**9.3 NO. 80 (LOT: 102; D/P: 413590) AUCKLAND STREET, NORTH PERTH - PROPOSED SINGLE HOUSE SECTION 31 RECONSIDERATION**

The purpose of this report is to reconsider a development application for a two storey single house at No. 80 Auckland Street, North Perth (the subject site) at the invitation of the State Administration Tribunal (SAT).

Figure 1 – Deferred Proposal

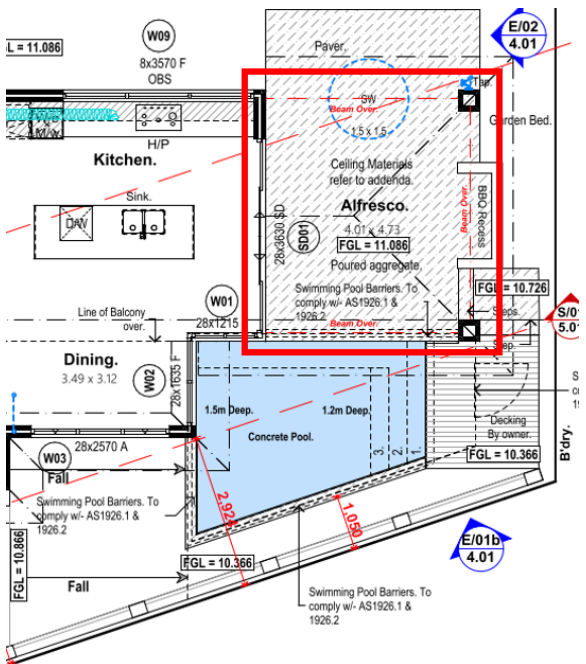
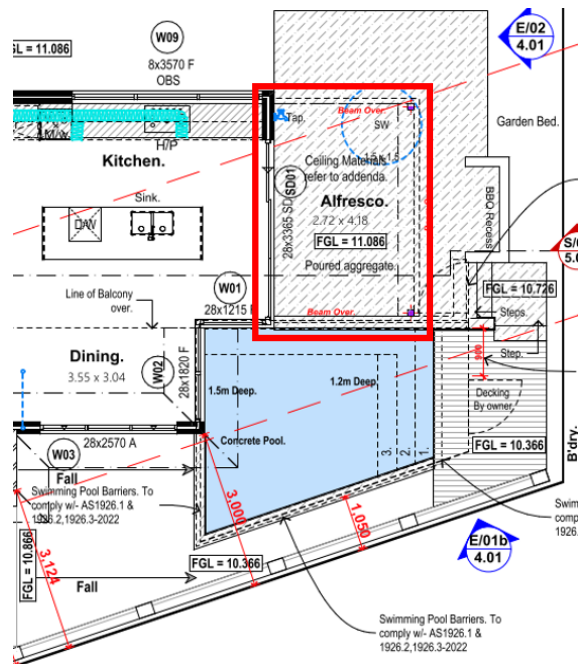
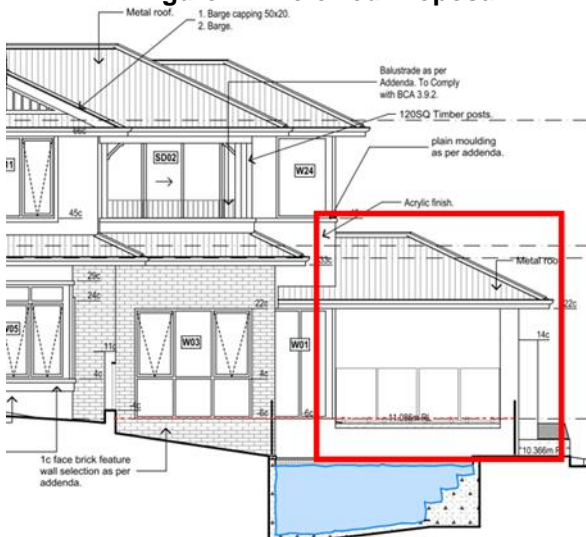
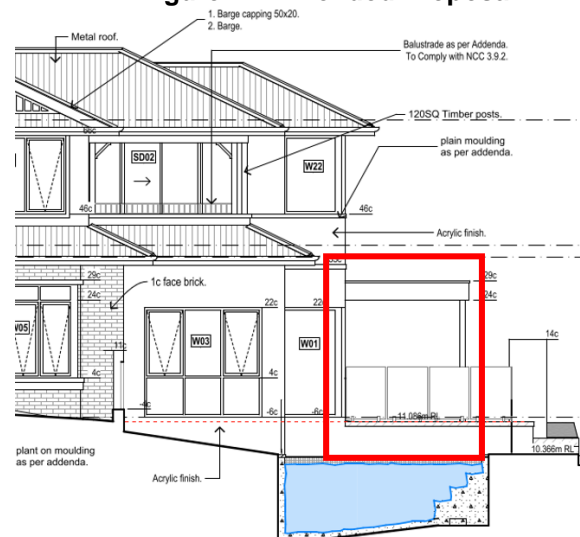
The applicant has made the following changes to the amended plans that relate to the proposed development's relationship with the southern adjoining property:

- Setback of the ground floor Alfresco to the southern lot boundary increased from 1.5 metres to 2.8 metres.
- Setback of the Alfresco to Auckland Street increased from 3.0 metres to 3.85 metres.
- Alfresco roof form change from a pitched roof to a flat roof. This has reduced the height from the former pitched roof of a maximum height of 4.2 metres to the proposed flat roof with a height of 3.1 metres.

- **Response to Deferral Reason:** The proposed increased setback of the alfresco from the southern adjoining property and from Auckland Street, as well as reducing the alfresco area and its height would improve graduation of the development as it transitions to the south. This would further reduce perceived impacts of building bulk and height to the southern adjoining property.

- **Response to Community Consultation Comments:** The proposal complies with the deemed-to-comply provisions of the R Codes in respect of building height, building setback to the southern lot boundary, solar access (overshadowing) and visual privacy (overlooking). This means that the proposed development would not detrimentally impact the amenity of the adjoining southern property. The increased setback of the alfresco and reducing its height has reduced overshadowing of the adjoining property by 1 square metre (0.13 percent).

Figure 5 – Deferred Proposal

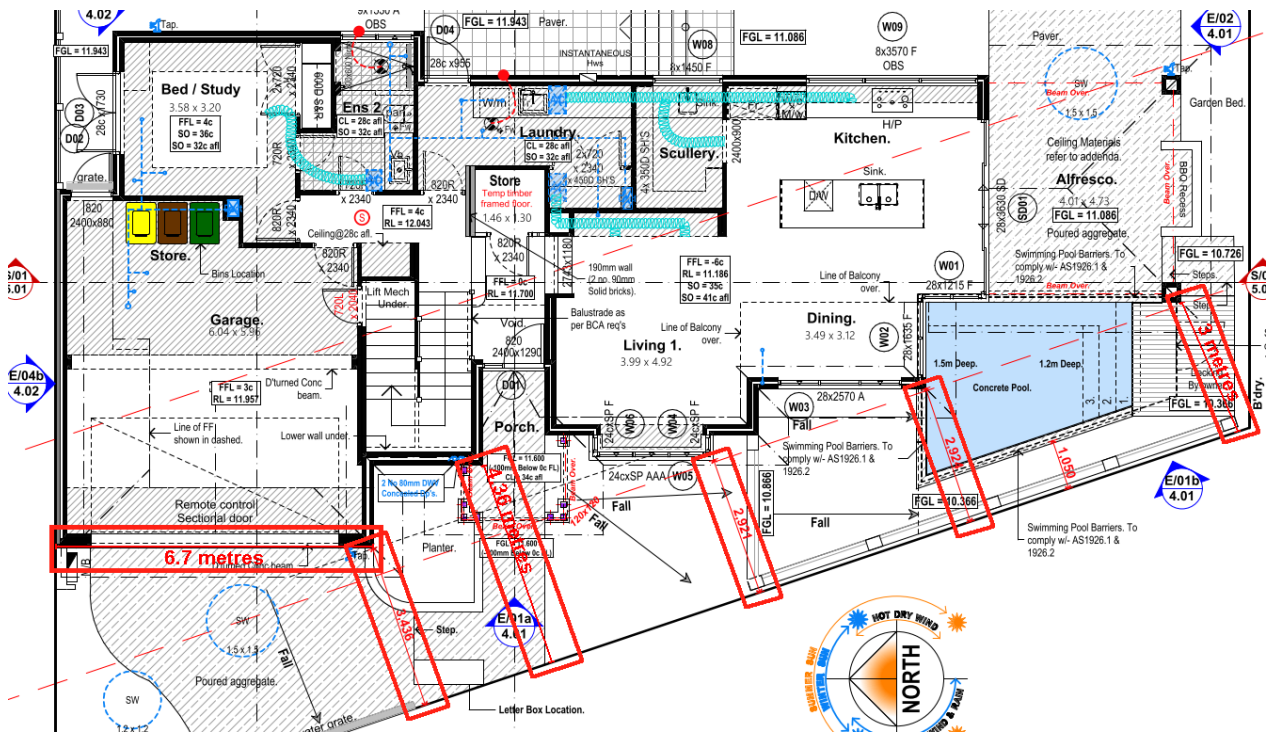
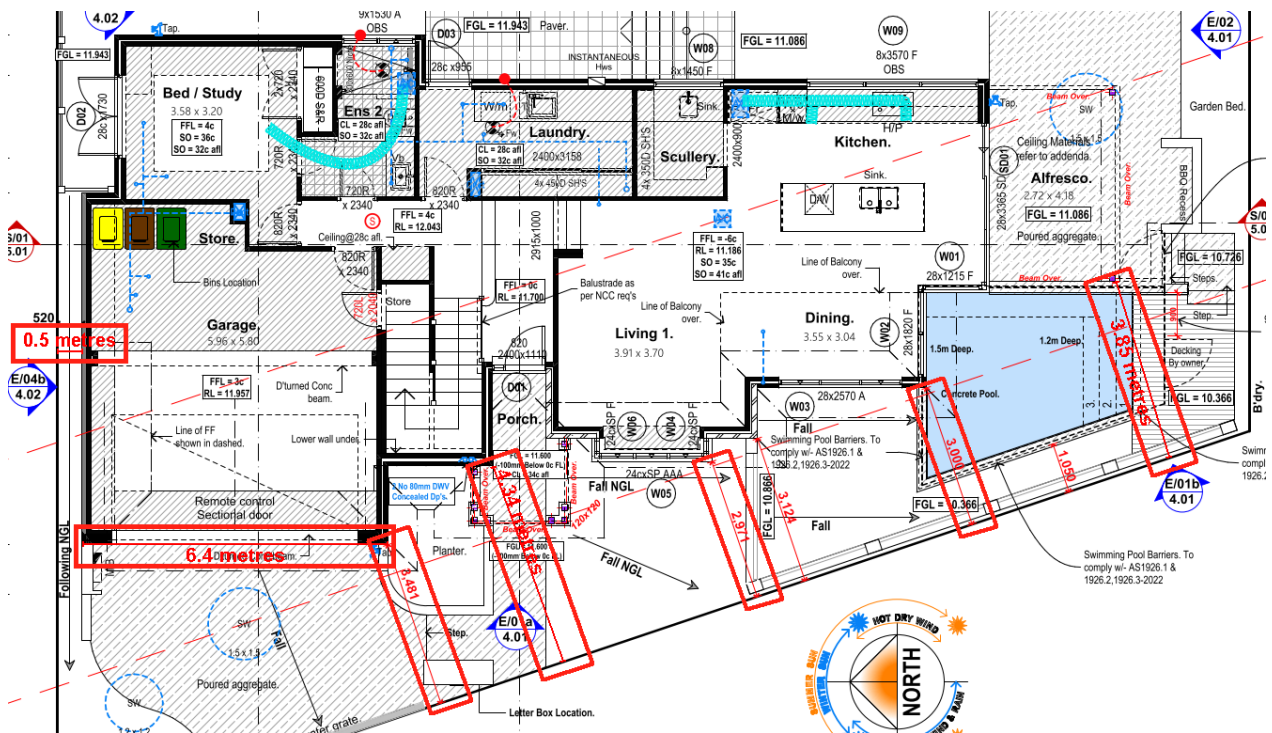
The applicant has made the following changes to the amended plans that relate to the proposed development's ground floor primary street setback:

- Setback of Living Room to Auckland Street increased from 2.92 metres to 2.97 metres.
- Setback of Dining Room to Auckland Street increased from 2.92 metres to 3.0 metres.
- Setback of the Alfresco to Auckland Street increased from 3.0 metres to 3.85 metres.
- Setback of the Garage to Auckland Street increased from 3.44 metres to 3.48 metres and the Garage width reduced from 6.7 metres to 6.4 metres. The Garage has also been setback from nil to 0.5 metres from the northern side boundary.

The applicant’s supporting information refers to the garage being modified to be setback 0.5 metres away from the northern side boundary. This creates separation from and reduces the perceived impact of bulk on the adjoining northern property at No. 31 Gill Street. It also allows for adequate space for bin storage.

- **Response to Deferral Reason:** The applicant has increased the street setbacks of all ground floor rooms including the Garage, Living Room and Dining Room, and the appurtenant Alfresco structure. The extent of the increase to the setback to the ground floor rooms is minor and is not substantial. The increased setback to the Alfresco structure is more substantial.

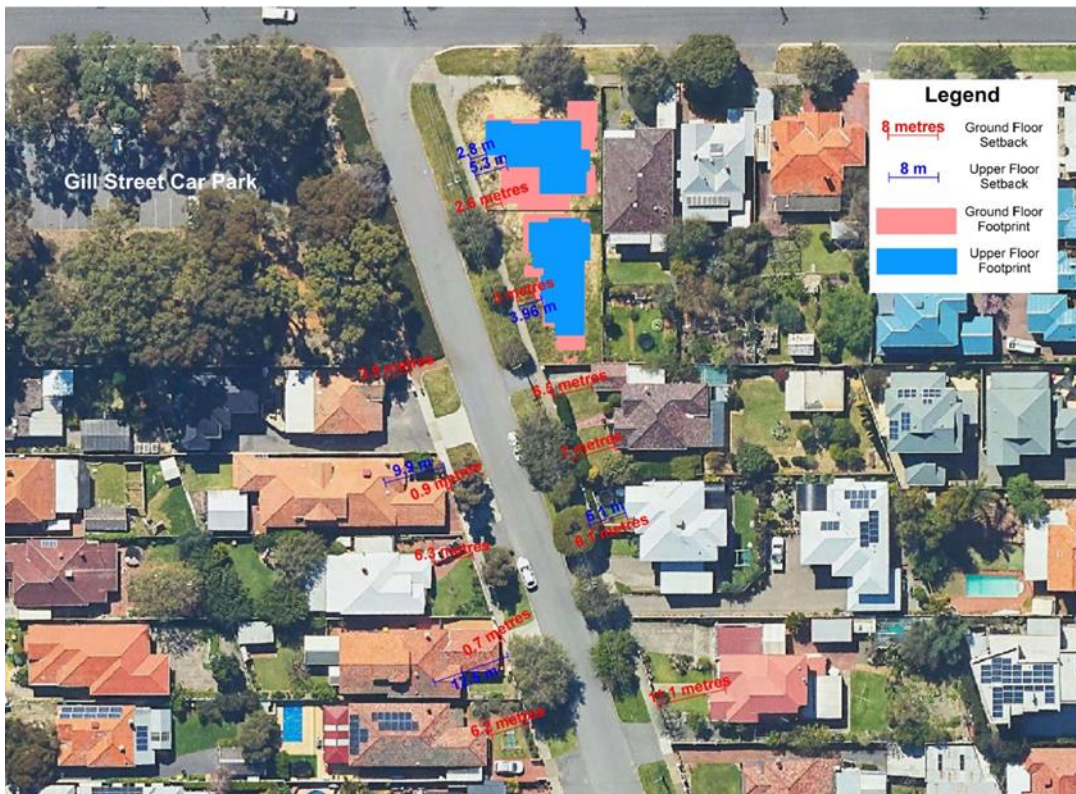
Concerns raised during community consultation referred to the proposed ground floor setback not protecting the streetscape and amenity of Auckland Street. This is because the intensity and scale of the proposed development is contrary to the pattern of development in the broader locality. This would impact the character of the streetscape and associated built environment. Concerns referred also to the primary street setback not being maximised as the sewer easement at the rear of the property can be encroached up to 0.6 metres.

- **Response to Community Consultation Comments:** The proposed dwelling has been designed so that it responds to the irregular lot shape and site characteristics. The diagram below shows the area of the site that could be developed for buildings in considering the deemed-to-comply street setback area and the sewerage easement located to the rear boundary of the site. This developable area is approximately 27 percent of the site. In considering this, the proposal seeks discretion to develop forward of the street setback line.

Figure 7 – Deferred Proposal

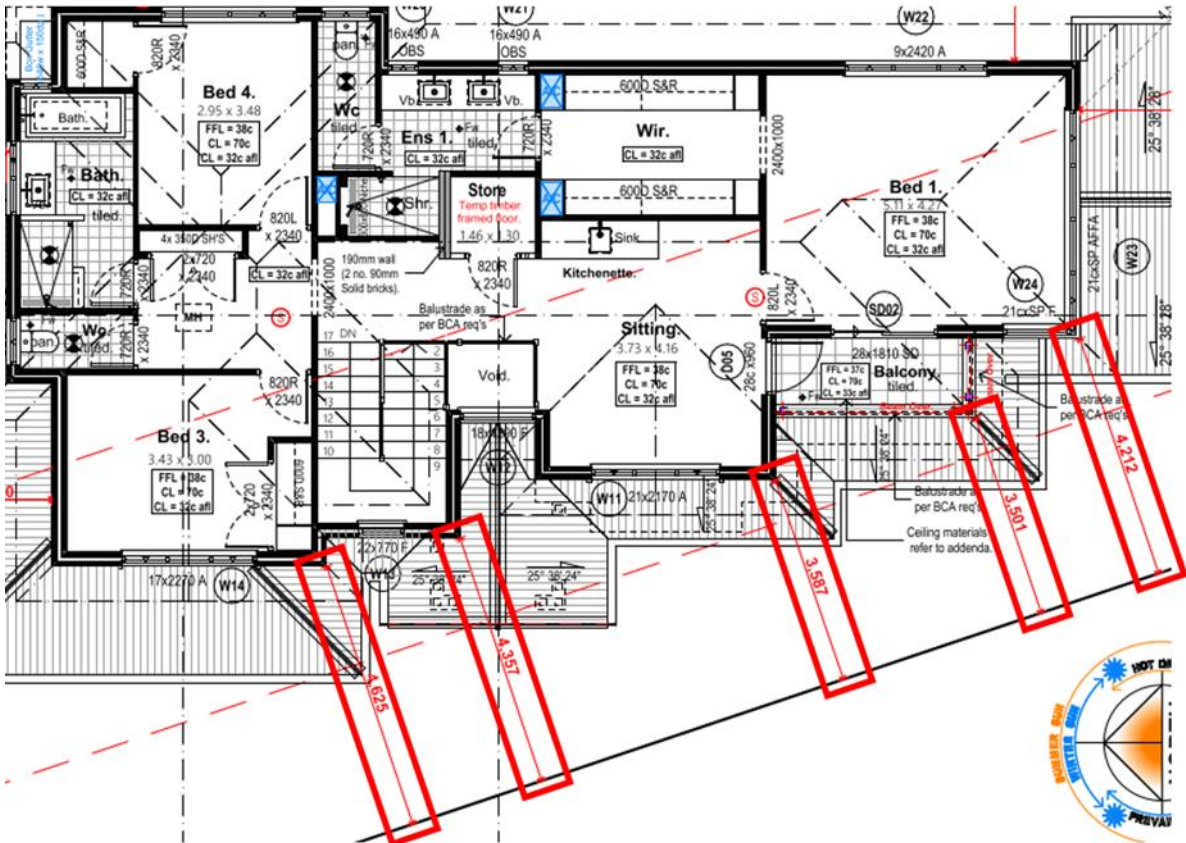
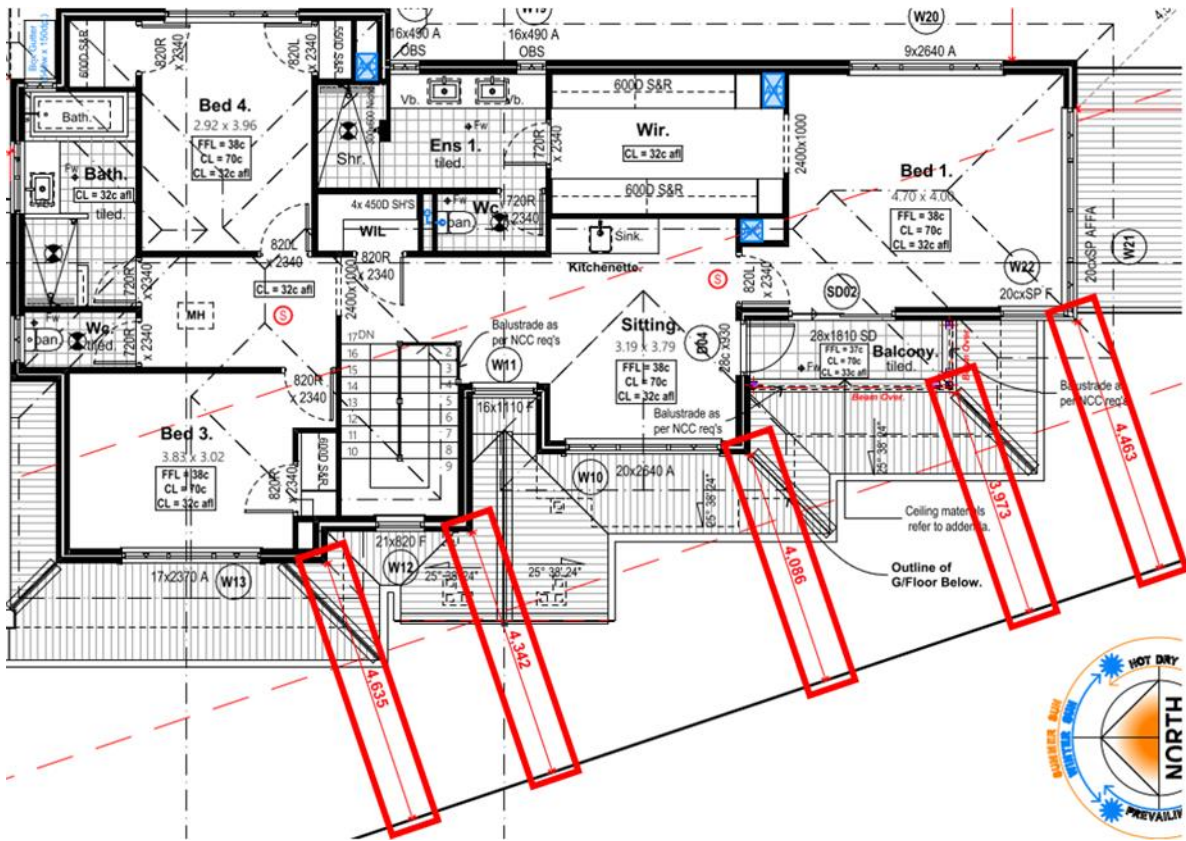
The applicant has made the following changes to the amended plans that relate to the proposed development's upper floor setbacks:

- Setback of the upper floor Bed 3 behind the ground floor predominant building line ~~increased~~ decreased from ~~4.34~~ 1.70 metres to 1.66 metres.
- Setback of the upper floor Staircase behind the ground floor predominant building line decreased from 1.44 metres to 1.37 metres.
- Setback of the upper floor Sitting Room behind the ground floor predominant building line increased from 0.67 metres to 1.12 metres.
- Setback of the upper floor Balcony behind the ground floor predominant building line increased from 0.58 metres to 1.0 metre.
- Setback of the upper floor Bed 1 behind the ground floor predominant building line increased from 1.29 metres to 1.49 metres.

- Response to Deferral Reason: The applicant has increased the upper floor setback of the sitting room to be 1.12 metres of rooms behind the ground floor predominant building line. This means that all upper floor rooms of the dwelling are a minimum 1.12 metres behind the ground floor predominant building line. The upper floor balcony setback has been increased to be 1.0 metre behind the ground floor predominant building line so that it meets the deemed-to-comply standard. These changes would further assist in delineating between the ground and upper floors. This would assist in reducing the building bulk impact to the street and provide greater visual relief.

- Response to Community Consultation Comments: The ground floor of the proposed development has been setback to ensure consistency with the ground floor setback of the northern adjoining dwelling and to step back as it transitions to the southern adjoining property.
